## Department of Energy

We received your April 13, 2012, letter expressing concerns regarding the operability and safety of the overall electrical distribution system at the Department of Energy (DOE) Waste Treatment and Immobilization Plant (WTP) at the Hanford Site. In the letter, you identified that although the WTP electrical distribution system meets many of the requirements of DOE orders and consensus industry standards, review by your staff raised concerns about the operability and safety of the overall electrical distribution system. Your letter requested a response within 120 days addressing the issues related to the design and construction of the WTP electrical distribution system identified in the Defense Nuclear Facilities Safety Board Staff Issue Report provided as an attachment to your letter.

## Waste Treatment and Immobilization Project Response to the Defense Nuclear Facilities Safety DNFSB Concerns: Electrical Distribution System

Example of Single-line for UPS power to large motors with Active Filter Connected.

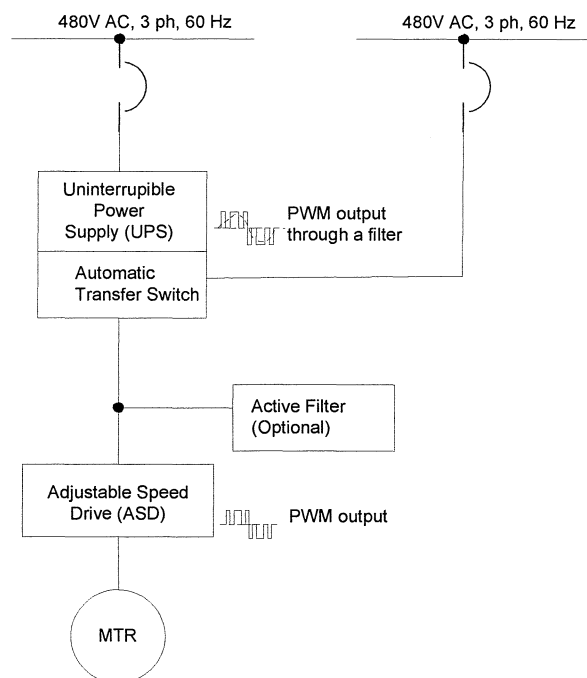
- c) DNFSB Key Point: The WTP project will need to determine the potential voltage fluctuations and harmonics inflicted on ASDs due to switching to and operating on power from UPS systems, and the effects on the ASDs and the driven motor's performance. The project team will have to evaluate the potential for these phenomena to impact system reliability, and develop and implement requirements for filtering equipment for each UPS, ASD, and motor combination that performs a SS or SC function.

- d) DNFSB Key Point: In these circumstances, the solutions required to address the problem were often expensive, labor intensive, and proprietary.

The illustration shows the application of an active filter to offset harmful harmonics, if they were to occur between the UPS and ASD of a motor circuit.

**Follow-up Action:** The project is already scheduled to develop Harmonic Analyses using ETAP Software to locate any buses which exceed the acceptability criteria defined in IEEE 519. Any buses with excessive harmonics will be evaluated and determined if equipment should be added to reduce harmonics to an acceptable level.

Typical Residual Voltage Decay of Induction Motors 200-300 HP

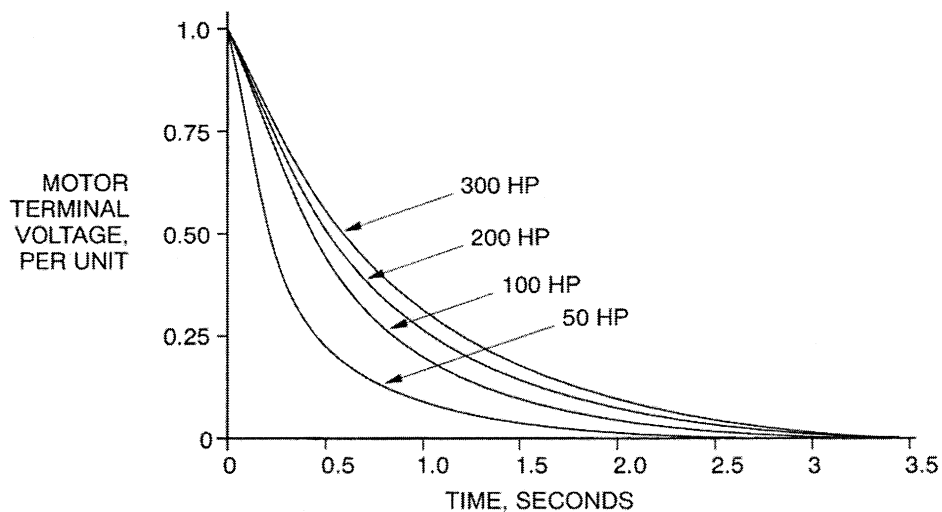
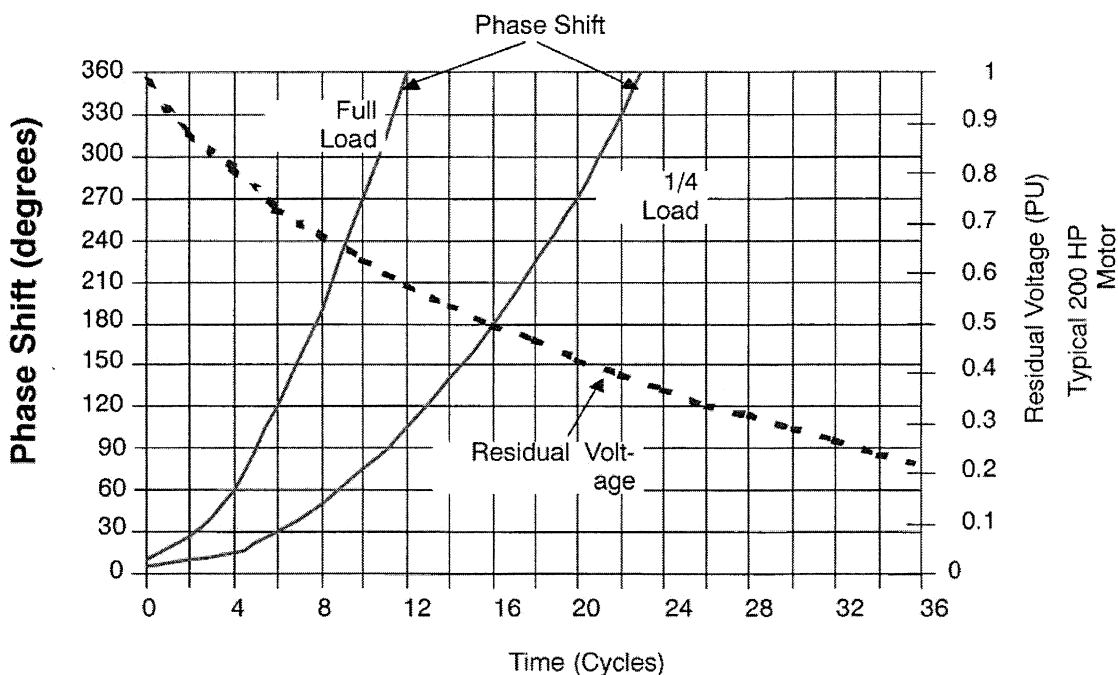
- a) DNFSB Key Point: When the motors are exposed to an automatic bus transfer or fast reclosing of the power supply breaker, there is a potential for the incoming voltage to be out of phase with that induced in the rotating machine. This can result in the development of a transient current and torque, the magnitude of which may range from 2 to 20 times the value rated for the machine, potentially causing damage to the motor.

Safe (slow) transfers or re-closings can be accomplished by a time delay equal to or greater than 1.5 times the open-circuit alternating-current time constant of the motor (NEMA MG-1-20.33.1).

This is equivalent to the residual voltage of the coasting motor decaying to approximately 25 percent of normal system voltage. A typical 200 hp motor decays to 25 percent of normal system voltage in approximately 0.5 seconds. Therefore, a time delay of 0.5 to 1.5 seconds over the range of 25 to 200 hp would be sufficient. Motors larger than 200 hp require slightly longer delays. Generally even the largest motor under load has its residual voltage decay to 25 percent within 5 seconds of loss of power.

The Figures on the next page, from two different sources, show that the residual voltage for both (typical) 300 hp and 200 hp motors will decay to 0.25 per unit (volts) in less than 1.5 seconds. Therefore, the 5 seconds listed above is a conservative number. However, the time for residual voltage to decay during fast transfers is not relevant to WTP since non-ASD connected motors will shutdown on loss of power and require manual restart. ASD connected motors, with automatic restart, are designed to catch the (spinning) motors on the fly.
